PRODUCT CHANGE NOTIFICATION

#PCN-TT-4OZT-16

Business Unit	Product Line Code	Type of Change	Action	Date of issue
TT	CL2	Mechanical	Notify Distributors and Field	8/1/2016

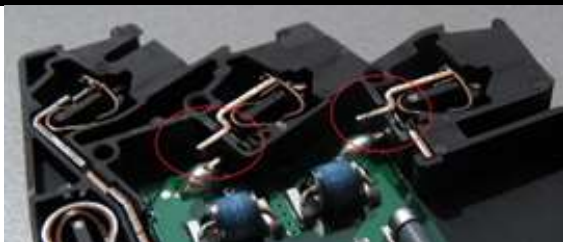
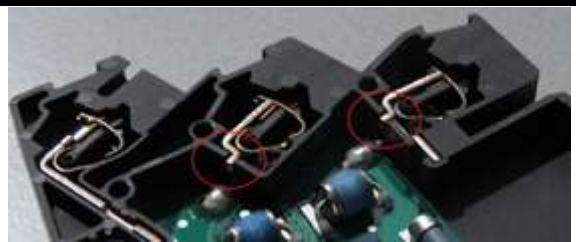
The unused soldering pin will be removed in order to improve the soldering process and the quality monitoring of the following TERMITRAB products.
